CORINNE WHITING PLACE SUBDIVISION

APPLICATION NUMBER 14 DATE December 3, 2009

REQUEST Subdivision

DETAIL SITE PLAN

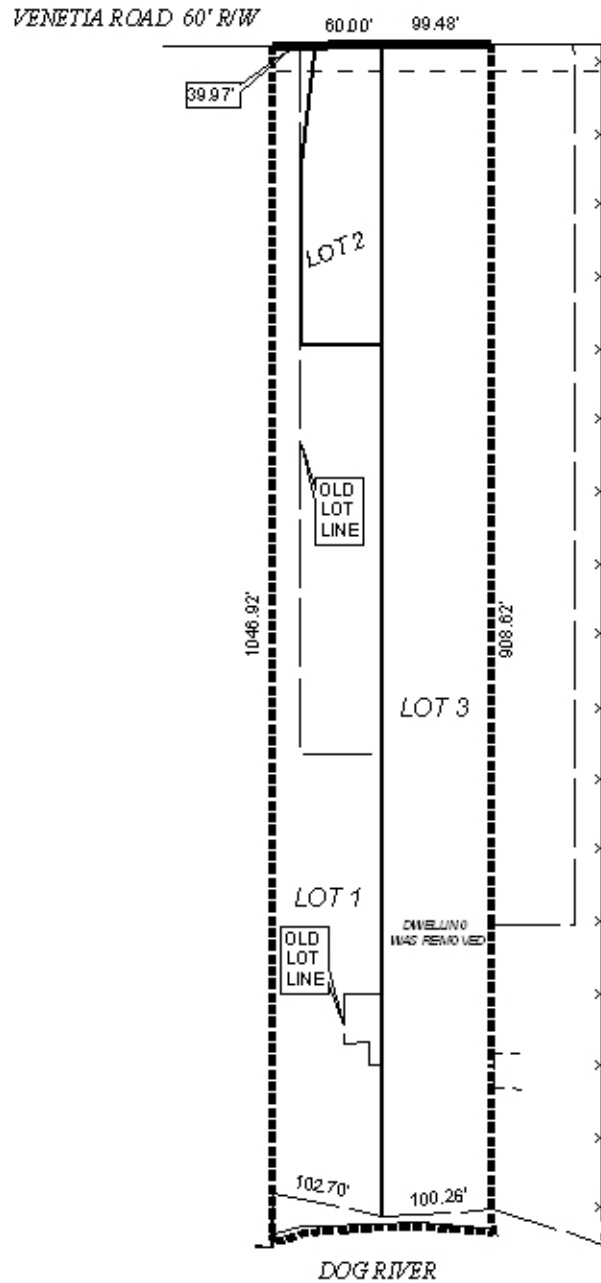
As proposed, Lots 1, 2, and 3 have approximately 40 feet, 60 feet, and 100 feet of frontage, respectively, along Venetia Road. Therefore, Lot 3 should be limited to one curb cut, while Lots 1 and 2 should be limited to one shared curb cut.

As illustrated, the common line between Lots 1 and 3 currently follows the footprint of an existing dwelling. The applicant now intends to demolish this structure and straighten the interior lot line. The common line between Lots 1 and 2 will also be moved approximately 375' to the North.

Section V.D.2 of the Subdivision Regulations states that lots shall be at least 60' in width at the minimum building setback line. Therefore, the minimum building setback line on Lot 1 should

be revised to provide 25' from where the "pole" meets the "flag" portion of the lot. A note should also be placed on the final plat stating that no future subdivision of Lot 1 will be allowed until additional frontage on a public street is provided.

The plat meets the minimum size requirement for developments with access to public water and sewer. However, it is requested that the applicant revise the preliminary plat to label the lots with their sizes in square feet, or provide a table on the plat with the same information.

- 1) placement of a note on the final plat stating that Lot 3 is limited to one curb cut, while Lots 1 and 2 are limited to one shared curb cut to Venetia Road, with the size, location, and design to be approved by Traffic Engineering and in conformance with AASHTO standards;

- 2) labeling of each lot with its size in square feet, or the provision of a table on the final plat with the same information;
- 3) revision of the minimum building setback line on Lot 1 to provide at least 25' from where the "pole" intersects the "flag" portion of the lot;

- 4) placement of a note on the final plat stating that no future subdivision of Lot 1 is allowed until additional adequate frontage on a public street is provided;
